Title:
**DRIVESHAFT ASSEMBLY
 REPLACEMENT**

Models:
 '04 – '07 Scion

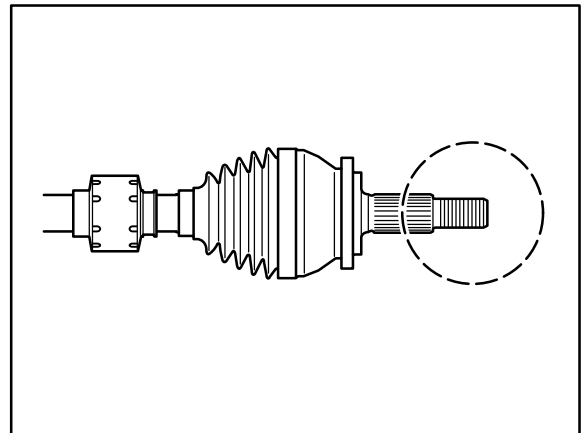
Clean the threaded area of the driveshaft with Toyota Brake Cleaner (or equivalent) to remove the anti-corrosion grease, oil, or foreign matter before installing the driveshaft into the vehicle.
